HISTORIC AND DESIGN REVIEW COMMISSION

June 17, 2020

HDRC CASE NO: 2020-001
ADDRESS: 819 LAMAR ST
LEGAL DESCRIPTION: NCB 1368 BLK 5 LOT 19
ZONING: R-6, H
CITY COUNCIL DIST.: 2
DISTRICT: Dignowity Hill Historic District
APPLICANT: Michael Cisneros/Harmony Custom Homes
OWNER: Nickolas Markov
TYPE OF WORK: Construction of a 2-story, single-family residential structure
APPLICATION RECEIVED: May 01, 2020
60-DAY REVIEW: Not applicable due to City Council Emergency Orders
CASE MANAGER: Edward Hall

The applicant is requesting conceptual approval to construct a 2-story, single-family residential structure on the vacant lot at 819 Lamar, located within the Dignowity Hill Historic District.

TYP. SIDING WALL SECTION

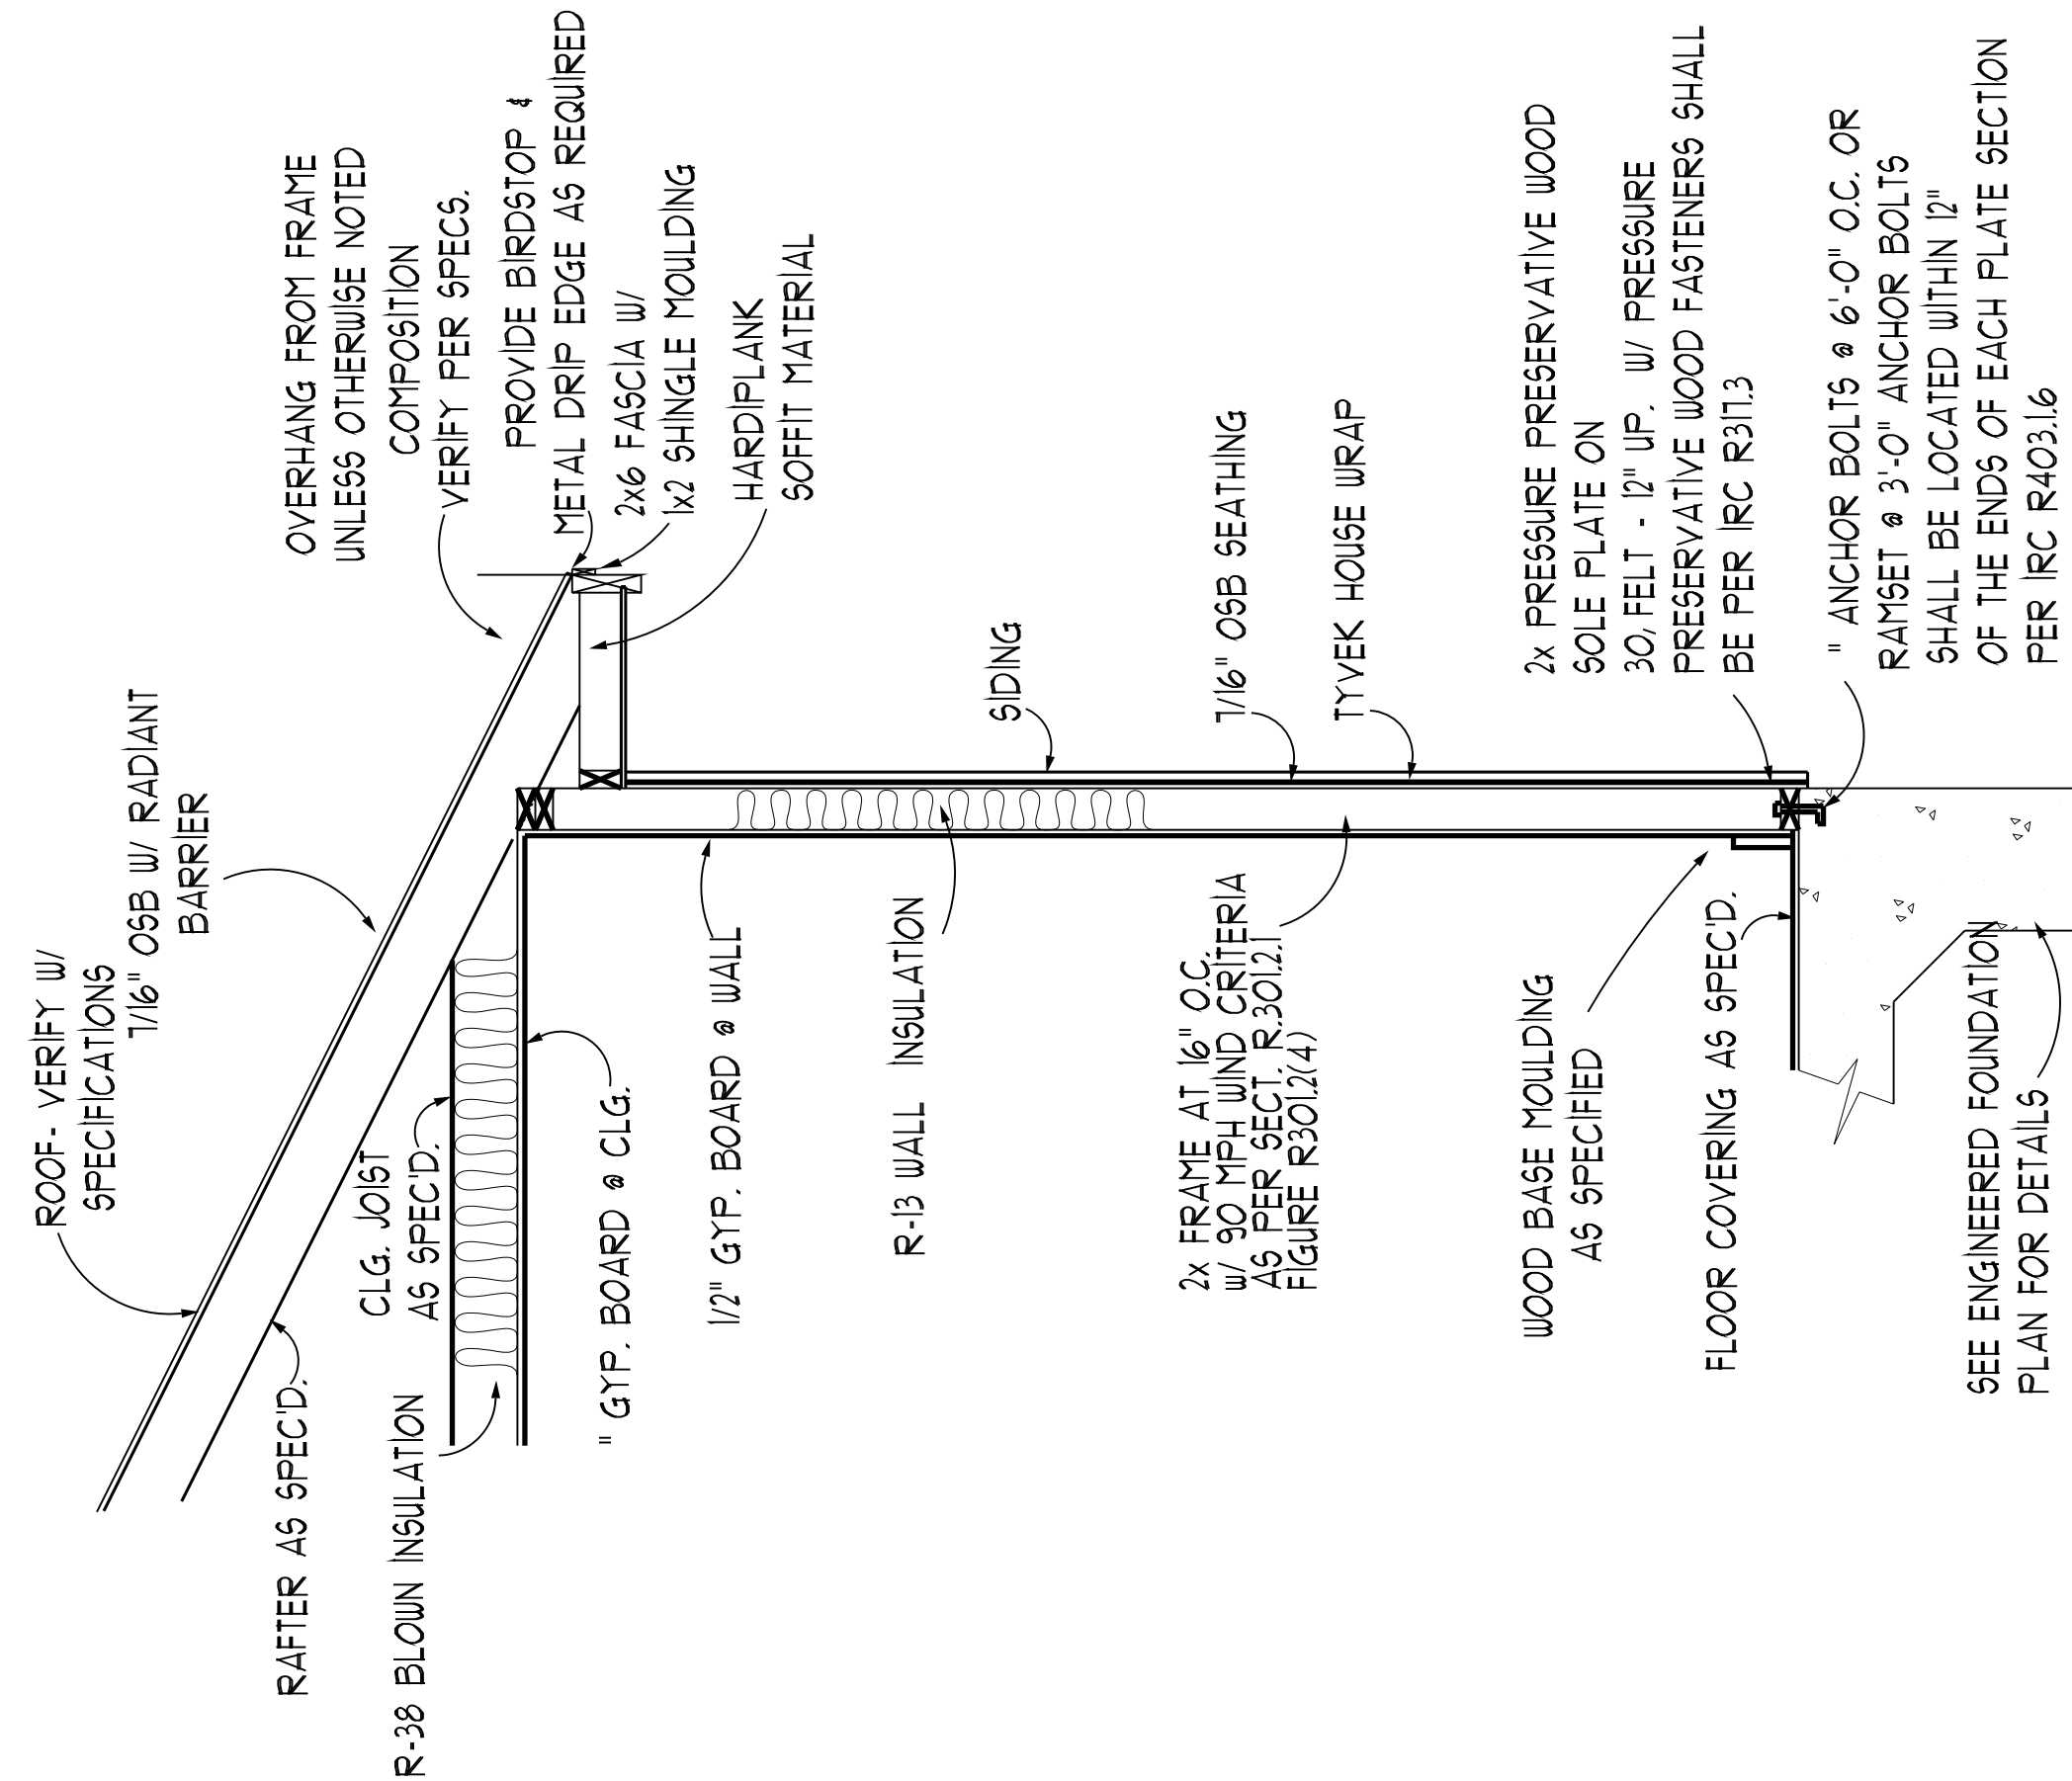
- j. MATERIALS – The applicant has proposed materials that include composite siding, composite trim, a composition shingle roof, and vinyl windows. Staff finds that all composite siding should feature an exposure of four inches, a smooth finish, a thickness of approximately ¾" and mitered corners. Additionally, composite trim, fascia board and soffits should feature smooth finishes.

- iii. That all composite siding feature an exposure of four inches, a smooth finish, a thickness of approximately ¾" and mitered corners. Additionally, composite trim, fascia board and soffits should feature smooth finishes.
